**Proposed Rezoning From “AGR” & “GB” To “G/IC” for
a Proposed “Social Welfare Facilities” (Residential Care Homes for The Elderly) (RCHE)
Lot 232 RP, 232 S.A RP, 232 S.A ss. 1 to 14, 232 S.B RP, 232 S.B ss. 1 to 27,
232 S.C to 232 S.E, 233 RP, 233 S.A to 233 S.M, 237 RP, 237 S.A to 237 S.R,
239 RP, 239 S.A to 239 S.G in D.D.23, Tung Tsz, Tai Po, N.T.
S12A Application for Planning Application No. Y/NE-TK/19
Response-to-Comment – EPD
(Updated 28 March 2025)**

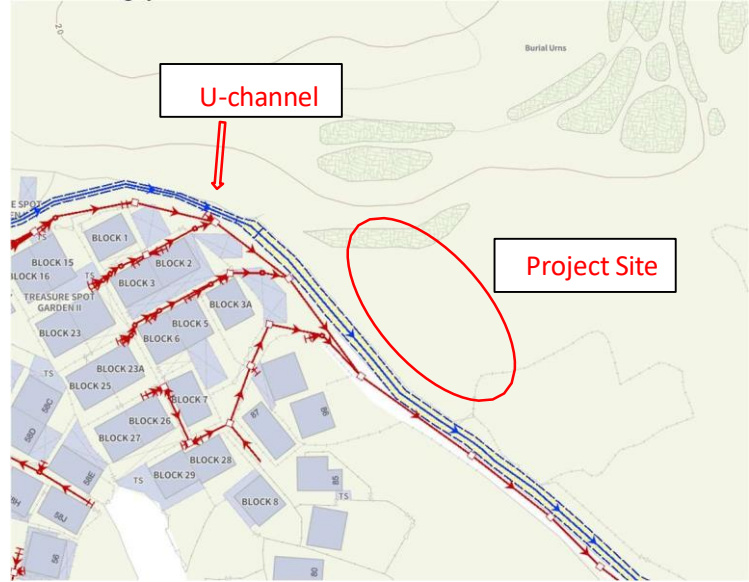
Comments	Response
<p>1. Comments of the Director of Environmental Protection Department as follows:</p> <p><u>EPD’s Comments on the EA</u></p> <p><u>Comments on General</u></p> <p>1. Section 1.1 and 1.2: Please revise as “... at Lot 232 <u>Various Lots</u> in D.D. 23...” and update all relevant sections accordingly.</p> <p><u>Comments on air quality assessment</u></p> <p>2. Section 2.1.1: Please supplement the information about the future predicted background air quality by quoting PATH data.</p> <p>3. Section 2.1.2: Since this section is about the ASRs but not “Air Quality Standards”, it should not be under Section 2.1. Please assign this section to be Section 2.2 and move it before the section “Construction Air Quality Impact”.</p> <p>4. Section 2.1.2: Please check whether there will be any planned development on the north-western side of the proposed development.</p> <p>5. Section 2.1.2: Please supplement a figure to show the location points of the identified ASRs of the proposed development during operational phase.</p> <p>6. Section 2.1.3: Please also include the buffer distance requirement for odour source.</p> <p>7. Section 2.2 and Table 2-4: The distances quoted in this section for Treasure Spot</p>	<p>Section 1.1 and 1.2 are revised accordingly.</p> <p>Future predicted background air quality is supplemented in Section 2.2.1 and Table 2-2 for review.</p> <p>The section of ASRs is moved to Section 2.2 accordingly.</p> <p>According to the Town Planning Board, there is no planned development within 500m study area of the proposed development.</p> <p>Representative ASRs of the proposed development during operational phase are presented in Figure 2.1.2 to 2.1.4. More than 5m buffer distance between the first-tier ASRs and the access road is allowed.</p> <p>Buffer distance requirement in accordance with HKPSG Ch.9 is supplemented in Table 2-3.</p> <p>Section 2.3 is revised accordingly.</p>
